#### PLANNING COMMISION MINUTES

#### APRIL 19, 2022

To: City of Chelsea Planning Commission From: Julia Upfal, Community Development Director, City of Chelsea Subject: Combined Preliminary and Final Site Plan- Heydlauff's Expansion Date: April 16, 2022

This letter is to provide feedback on the 4 plan sheets and 5 architectural plan sheets submitted to the City of Chelsea for the expansion of Heydlauff's showroom, including a 592 SF building addition, located at 107, 107.5, 109, and 113 N. Main Street, Chelsea, Michigan 48118. The Planning Commission shall review these plans with consideration of the following comments from the Planning and Zoning Administrator.

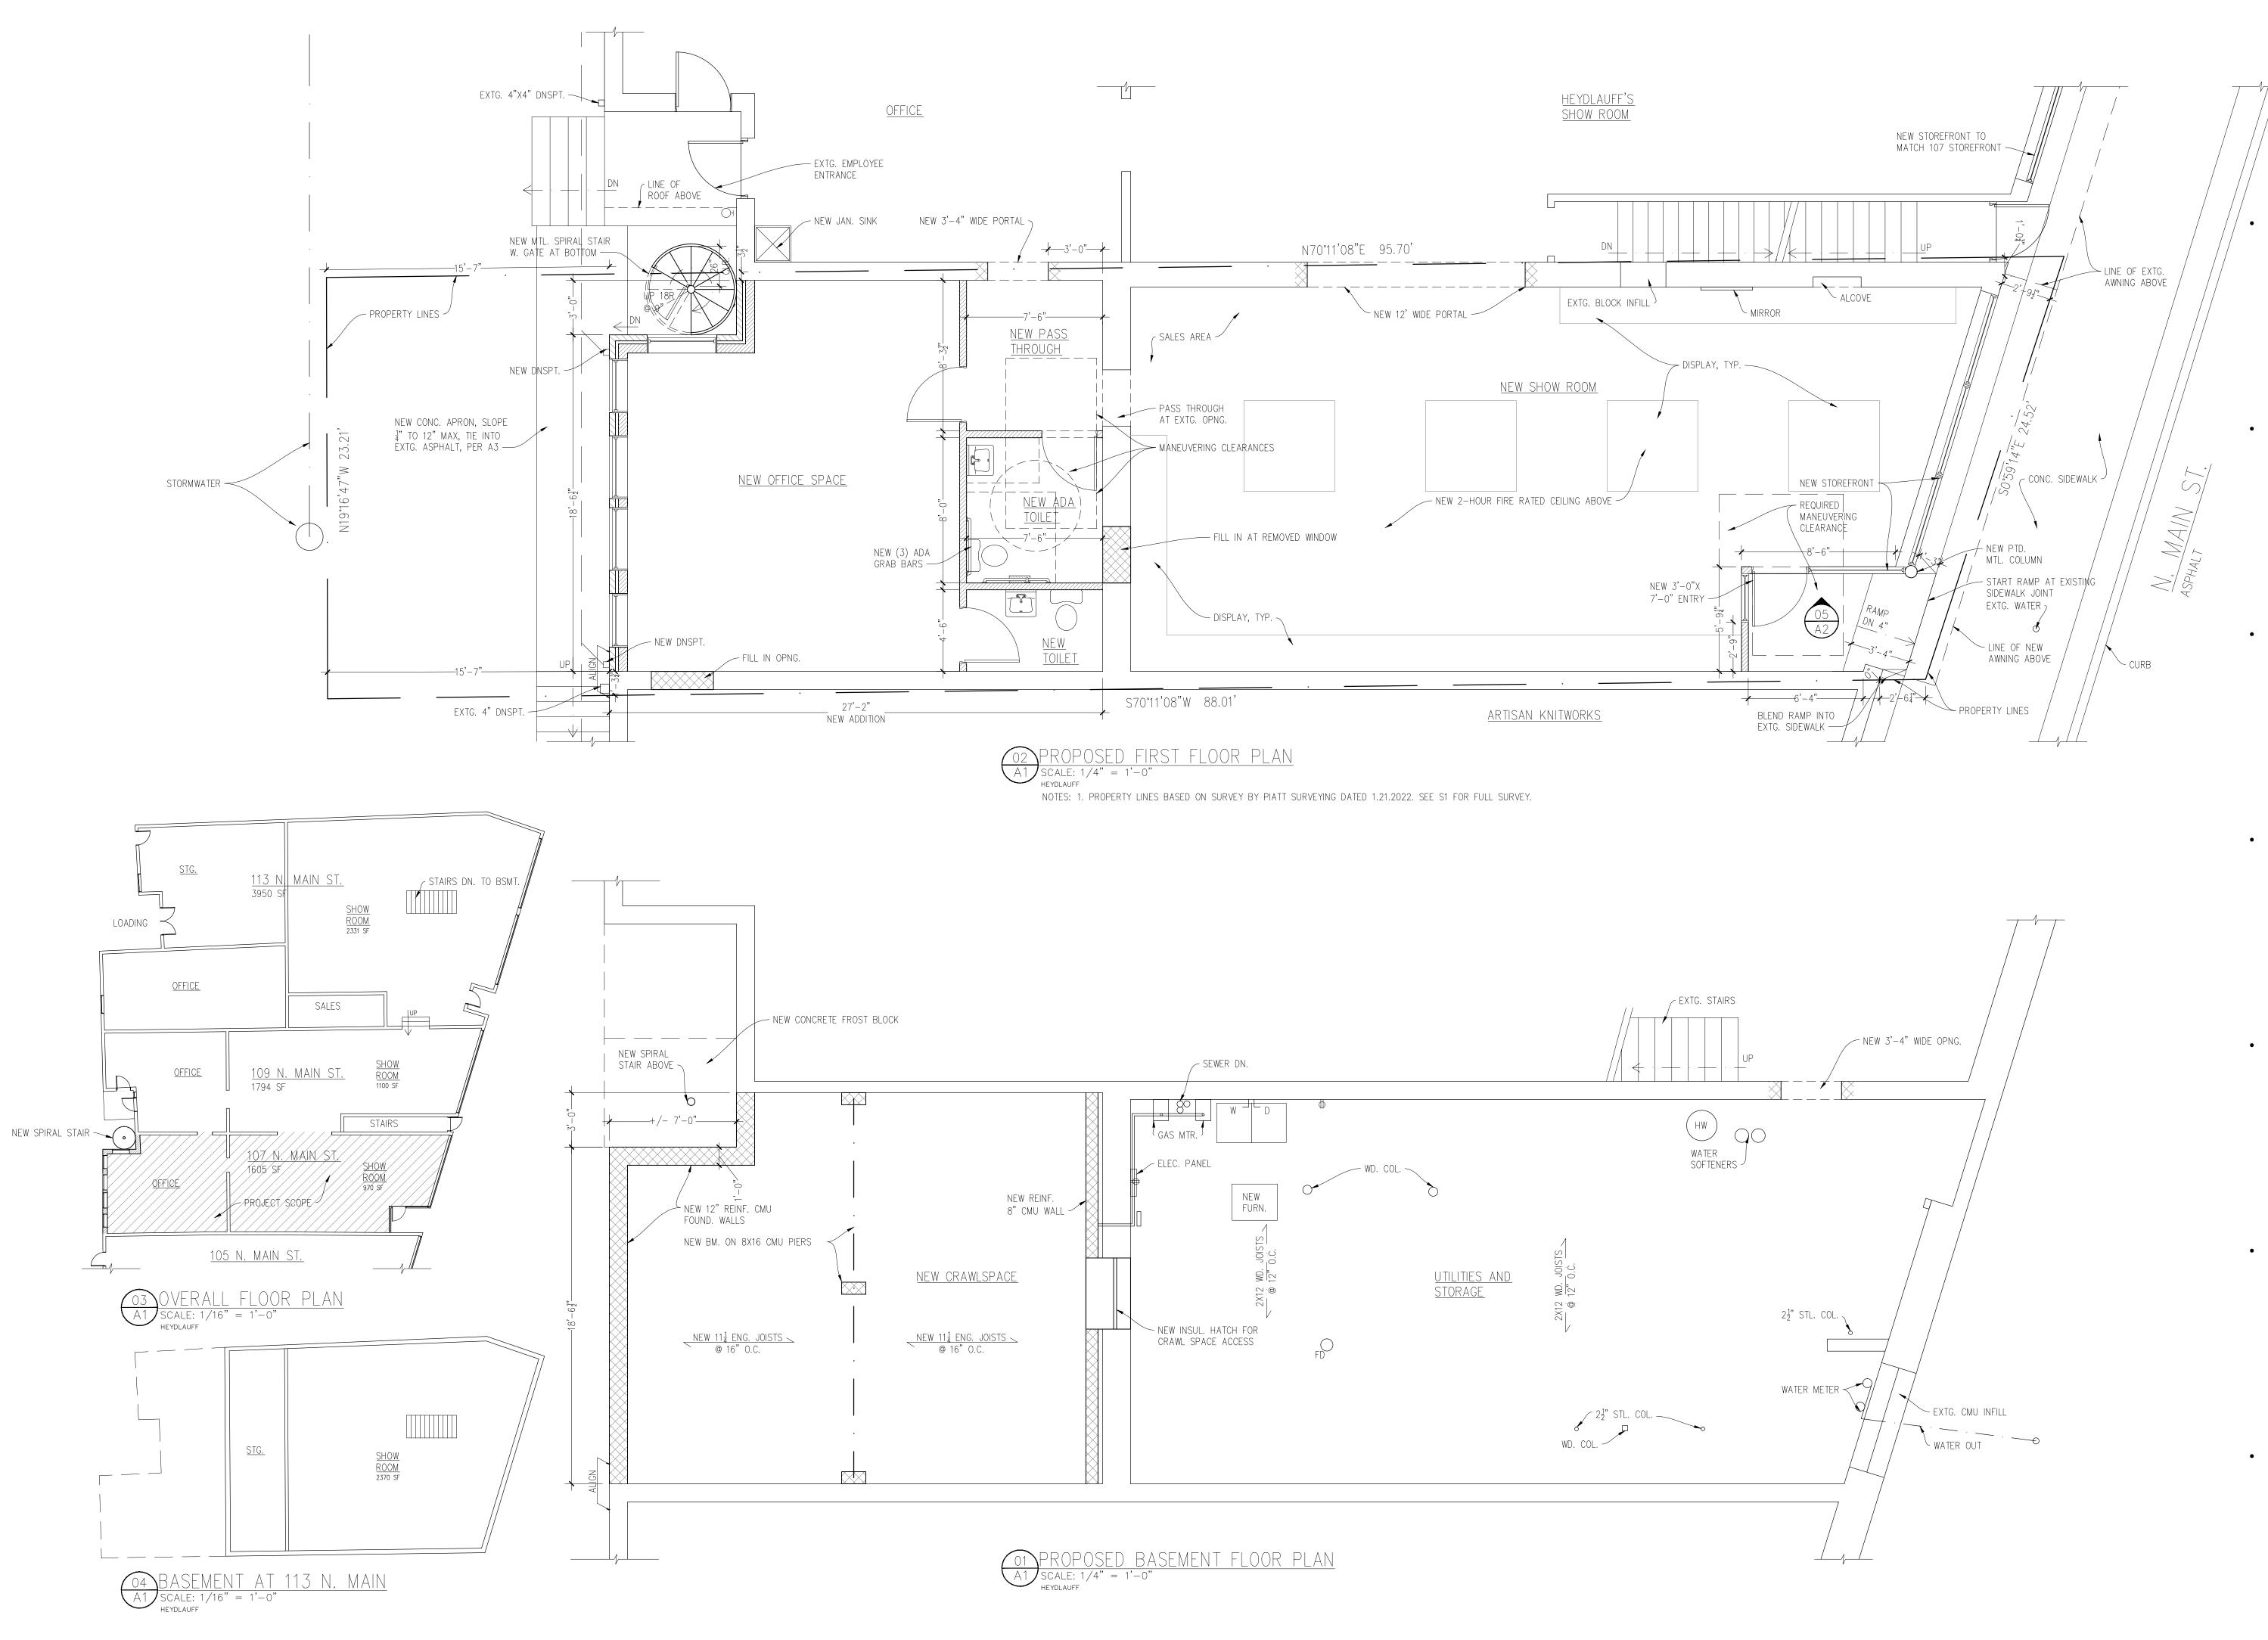
8. The site plan does not show the location of all easements. For example, there is a 20 ft wide easement around the City's stormwater line, 10 ft on either side of the line. **The location of all proximate easements must be included on the next set of revisions to proceed to Planning Commission review.**

a. This easement has been added to the site plan on Sheet T1.
